Bridge Division,
December 1, 1961.

RE: W.P. 275-60
Carp River Bridge
Hwy. 44 - Dist. #9

Re: Proposed Crossing - Hwy. 44 and Carp River,
Township of Huntley, District No. 9,
W.P. 275-60.

PROPOSED CROSSING
HIGHWAY 44 AND CARP RIVER
TOWNSHIP OF HUNTLEY, DISTRICT NO. 9
WP 275-60

SECTION A-A
 Scale: 1 in. = 8 ft.

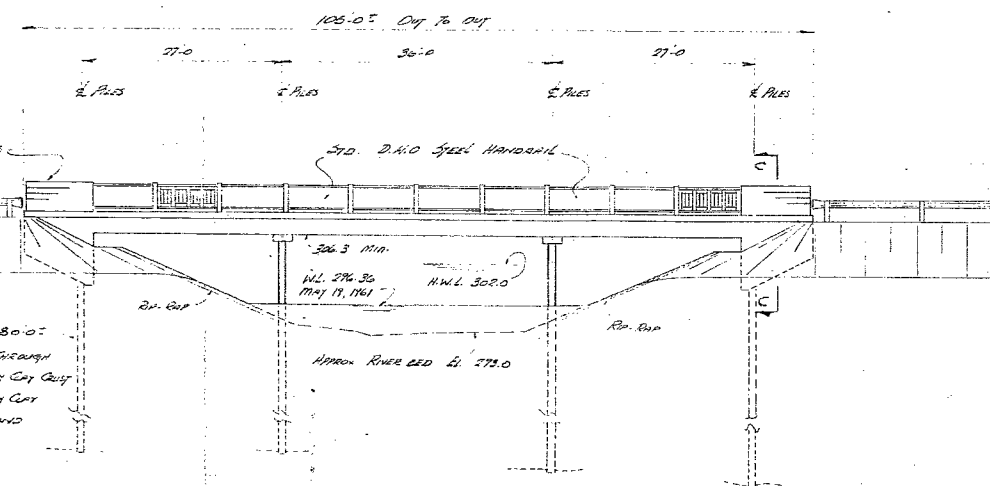
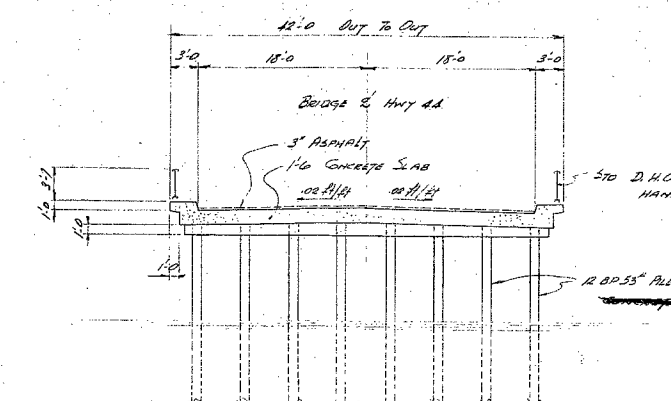
Comment:
 The pier at the Abutment location should be entered in order to make the horizontal thrust.
